TR-7 Adequacy responses

June 10, 2020
Permit No. M-1977-410

**RE: Cross Gold Mine, Permit No. M-1977-410, Technical Revision No. 7 (TR-07),
Preliminary Adequacy Review**

Project		Idaho Tunnel Portal Slope Stability			
Title		Schematic Illustration of Idaho Tunnel Slope Stabilization			
 GRAND ISLAND RESOURCES		Project No. US 0401		File No.	
		GIS:	JST	06/16/20	Scale As Shown
		Check:	JST	06/16/20	Rev 0
		Review:	JST	06/16/20	Figure 6

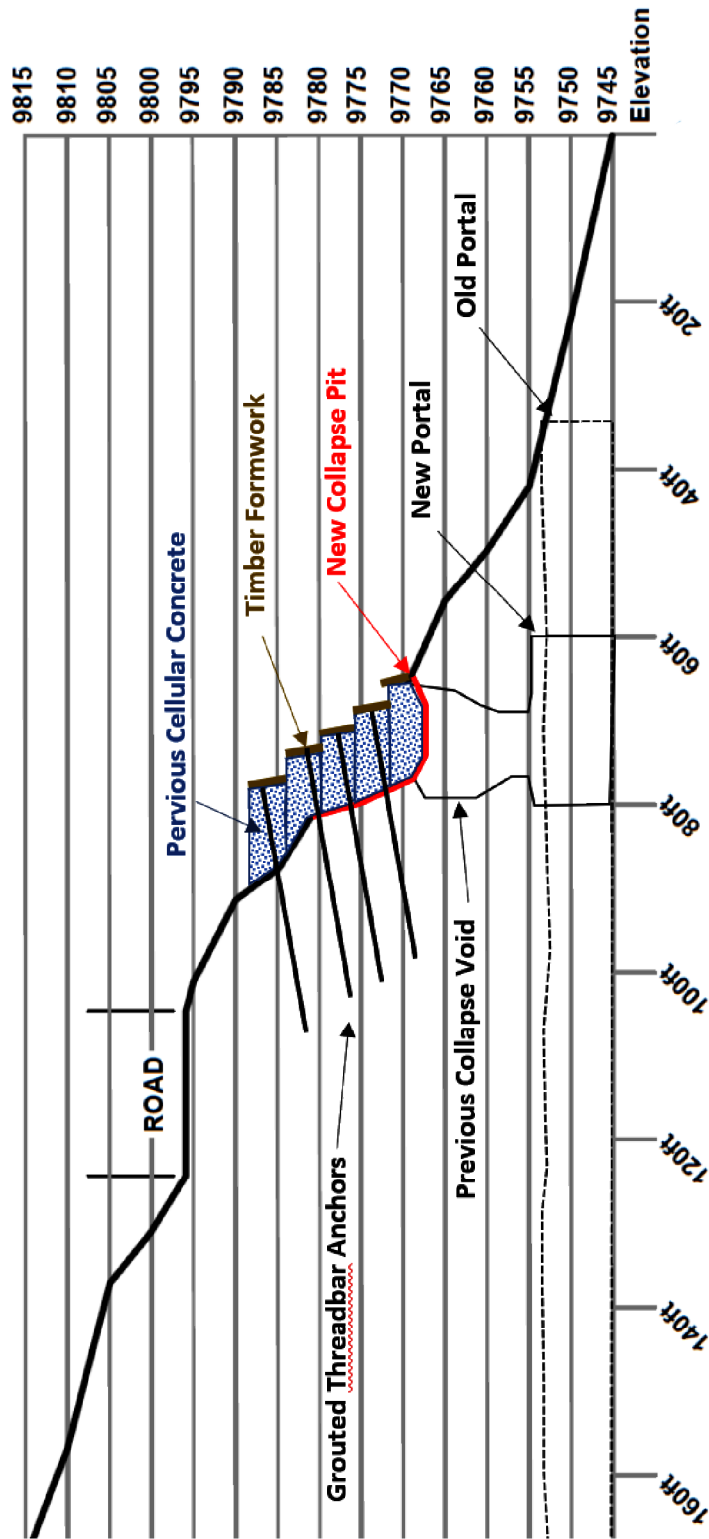
- 5) *The enclosed Memorandum from Peter Hays, DRMS recommends a monitoring program be prepared for monitoring and measuring the collapse void to prevent and/or prepare for damage to Caribou Road. Given the significant potential for off-site damage and impacts to Caribou Road due to current slope conditions (including the collapse void), the Division recommends this proposed monitoring program be submitted as soon as possible in a separate Technical Revision that can be reviewed and approved outside of the review process for TR-07 (which may be extended to allow for additional data collection and analysis).*

After the cellular concrete placed in the subsidence pit cures for several weeks, GIR proposes to begin placing an additional 3 or 4 staggered layers of this material to partially fill in the saddle over the tunnel for long-term stability of the tunnel portal. Each lift is anticipated to be 4' – 5' thick placed in a set back or stairstep fashion. Individual lifts will be secured to the preceding lift with No. 8 rebar anchors on 1' center-to-center spacing. 8" x 3" x 8' long Douglas Fir lagging will be used as formwork and left in-place as facing. This entire mass will be anchored into the slope using grouted threadbar to serve as a slope retaining structure. Figure 6 presents a schematic illustration of this proposed design.

The pervious cellular concrete serves to provide drainage behind the retaining wall with greatly reduced lateral earth pressure relative to granular fill due to its high cohesive strength and stiffness. The cellular concrete is stronger than granular fill and the low weight of the material reduces driving forces that could destabilize the slope.

GIR proposes to construct the individual lifts or layers in approximate 2-week intervals such that the entire stabilization effort can be completed by late August. Once construction has been completed, as-built information on the final slope geometry, cellular concrete and anchor placement will be used to provide stability analyses which will demonstrate that the slope meets the long-term stability requirements of MLRB policy.
